V2500-A5/D5 SERIES PROPULSION SYSTEM SERVICE BULLETIN

This document transmits Revision 2 to Service Bulletin V2500-ENG-72-0447.
Document History

V2500-ENG-72-0447

ENGINE – INNER AND OUTER COMBUSTION CHAMBER LINERS WITH ADDITION OF SINGLE CRYSTAL MATERIAL ON ROWS 3 AND 4

Location and Identification of the 30D and 40D Combustion Chamber Liner Segments
Figure 1, Sheet 1

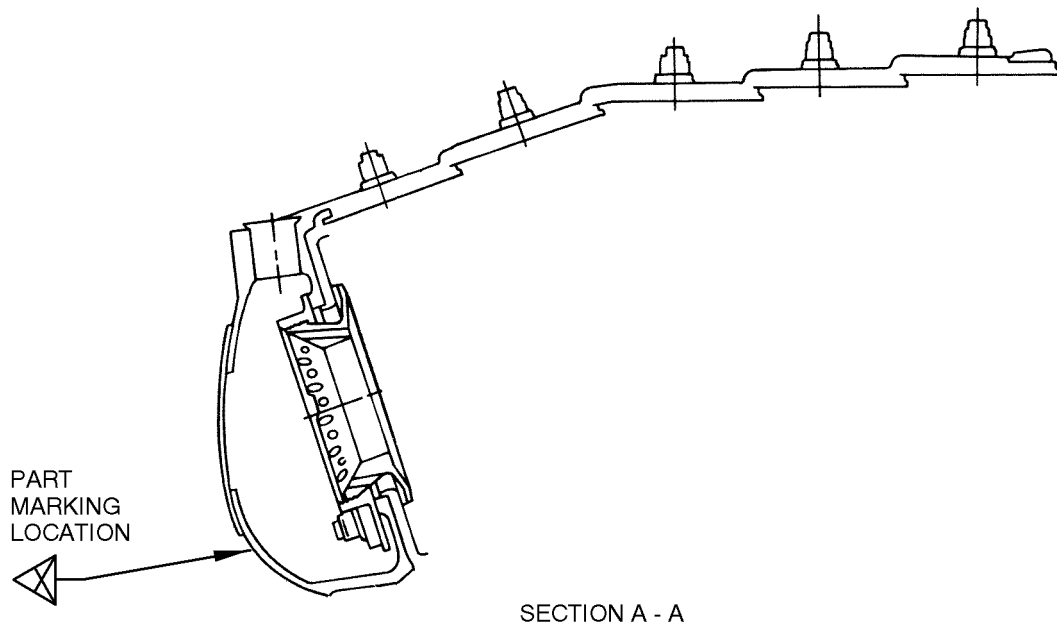
R (1) Replace 10 30D Combustion Chamber Liner Segments, PN 2A3316 with PN 2A3804
R by the procedure in Reference 7 or 8, Engine Manual, Chapter/Section
R 72-42-61, Repair 015 (VRS 3540). See Figure 1, Sheet 1 for the location of
R the parts.

R (2) Replace 10 40D Combustion Chamber Liner Segments, PN 2A3317 with PN 2A3805
R by the procedure in Reference 7 or 8, Engine Manual, Chapter/Section
R 72-42-61, Repair 015 (VRS3540). See Figure 1, Sheet 1 for the location of
R the parts.

R CAUTION: DO NOT TIGHTEN THE COMBUSTION CHAMBER LINER SEGMENTS TO A TORQUE VALUE OF
R MORE THAN 50.0 LBF-IN (5,649 NM). OVERTIGHTENING CAN CAUSE THE STUD BASE
R AND THREADS TO CRACK.

Location and Identification of the 30D and 40D Combustion Chamber Liner Segments
Figure 1, Sheet 2

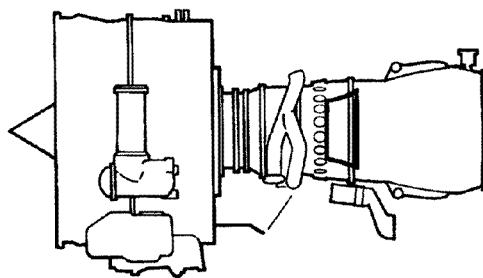
R (3) Identify the modified outer combustion chamber assembly by the vibration
R peen method specified in Reference 9, Standard Practices Manual,
R Chapter/Section 70-09-00, Marking of Parts. See Figure 1, Sheet 2 for the
R part marking location. Part number identification is provided in the list
R that follows:

Location and Identification of the 3ID and 4ID Combustion Chamber Liner Segments
72-44-30
Figure 2, Sheet 1

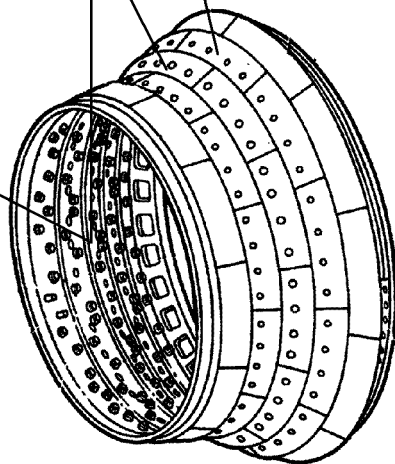
- (4) Replace 10 3ID Combustion Chamber Liner Segments, PN 2A3326 with PN 2A3806 by the procedure in Reference 7 or 8, Engine Manual, Chapter/Section 72-44-30, Repair 001 (VRS3173). See Figure 2, Sheet 1 for the location of the parts.

- (5) Replace 10 4ID Combustion Chamber Liner Segments, PN 2A3322 with PN 2A3807 by the procedure in Reference 7 or 8, Engine Manual, Chapter/Section 72-44-30, Repair 001 (VRS3173). See Figure 2, Sheet 1 for the location of the parts.

2A3322
4ID COMBUSTION CHAMBER
LINER SEGMENT
REPLACE AS SPECIFIED IN TEXT
(QUANTITY 10)

2A3326
3ID COMBUSTION
CHAMBER
LINER
SEGMENT
REPLACE AS
SPECIFIED IN TEXT
(QUANTITY 10)

Location and Identification of the 3ID and 4ID Combustion Chamber Liner Segments
Figure 2, Sheet 2

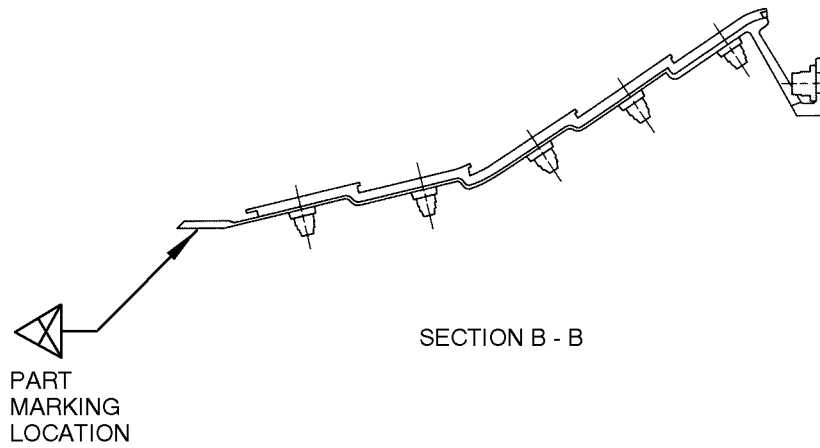
- (6) Identify the modified outer combustion chamber assembly by the vibration peen method specified in Reference 9, Standard Practices Manual, Chapter/Section 70-09-00, Marking of Parts. See Figure 2, Sheet 2 for the part marking location. Part number identification is provided in the list that follows:
